HISTORIC AND DESIGN REVIEW COMMISSION

April 15, 2015

Agenda Item No: 30

HDRC CASE NO: 2015-141
ADDRESS: 114, 130, 134 SOLEDAD ST, 140 E HOUSTON
LEGAL DESCRIPTION: NCB 106 BLK LOT A12 THRU A16 114 TO 128 SOLEDAD ST
ZONING: D H HS RIO-3
CITY COUNCIL DIST.: 1
DISTRICT: Main/Military Plaza Historic District
LANDMARK: Devine Building
APPLICANT: Travis Jeakins/Woodbine Development
OWNER: Service Lloyds Insurance Co
TYPE OF WORK: Demolition with new construction
REQUEST:

PROPOSED DEMOLITION:

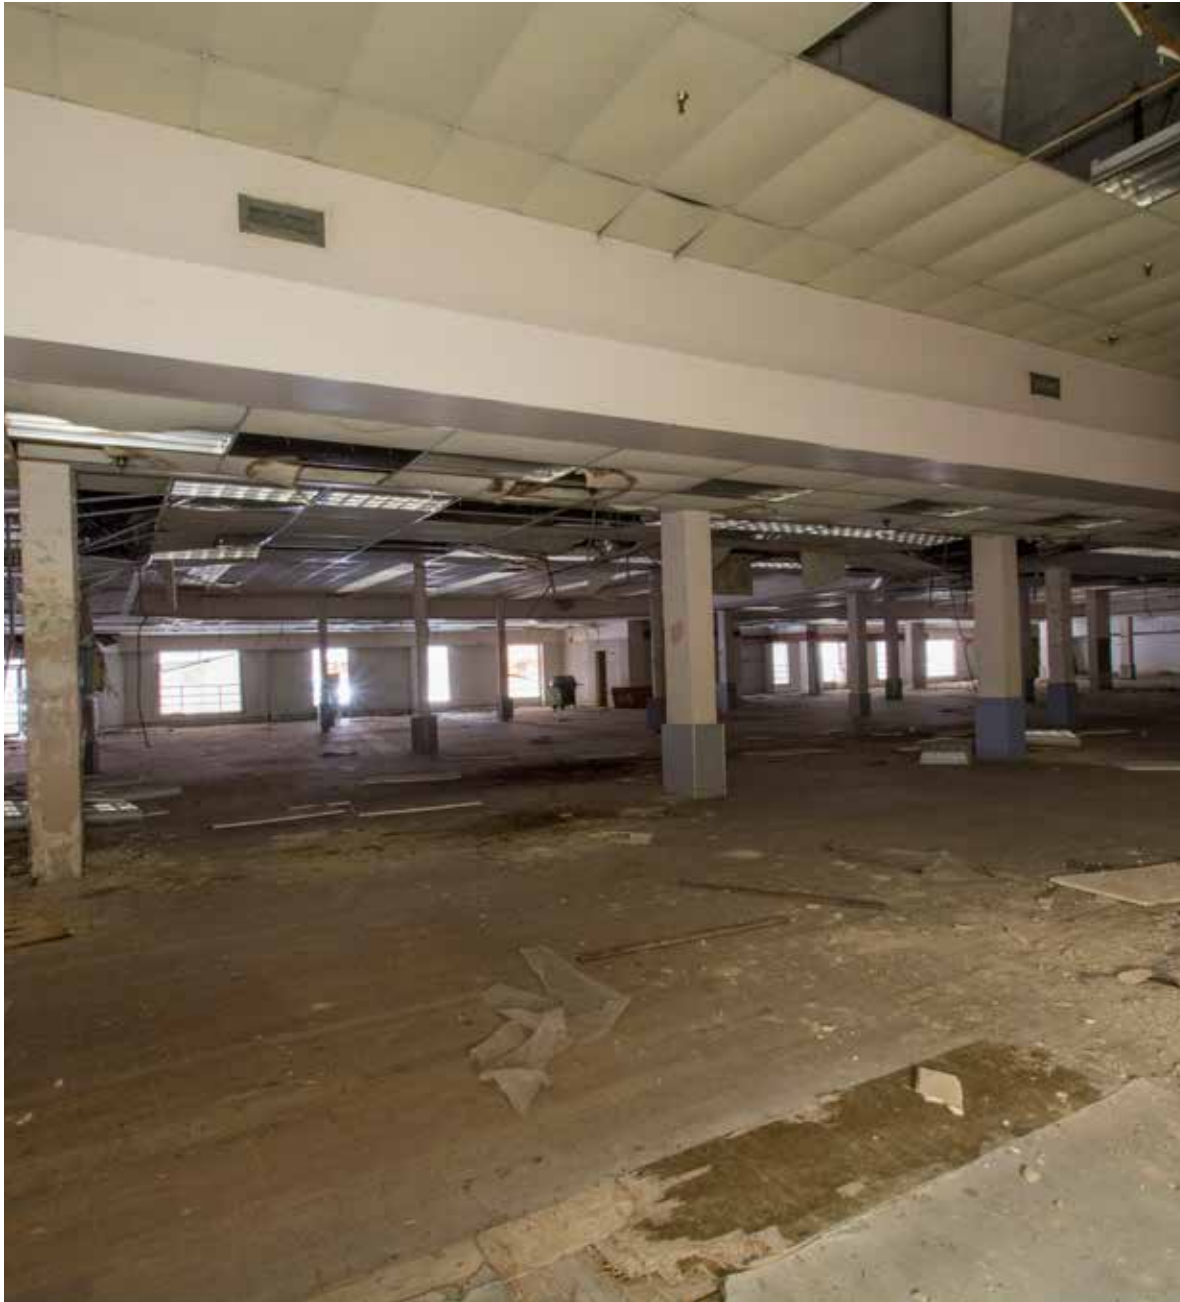
Woodbine proposes to remove all of the structures on the parcel with the exception of the 1914 Wall along the San Antonio River. The 1914 Wall will be protected in place.

PROPOSED DEMOLITION:

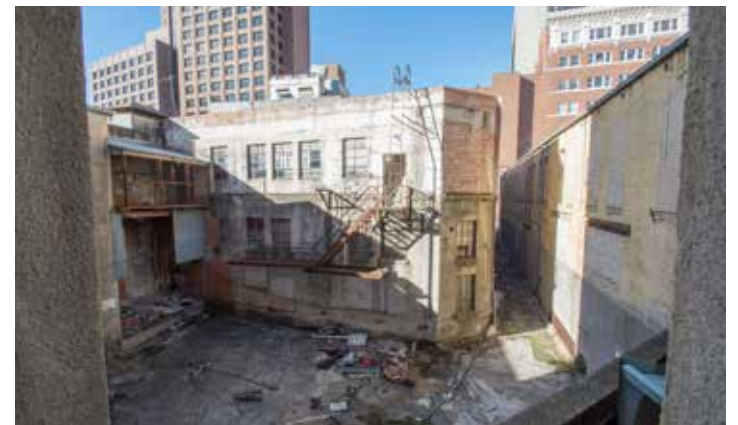
Woodbine proposes to remove all of the structures on the parcel with the exception of the façade fronting Soledad Street. This façade will be protected and renovated in place.
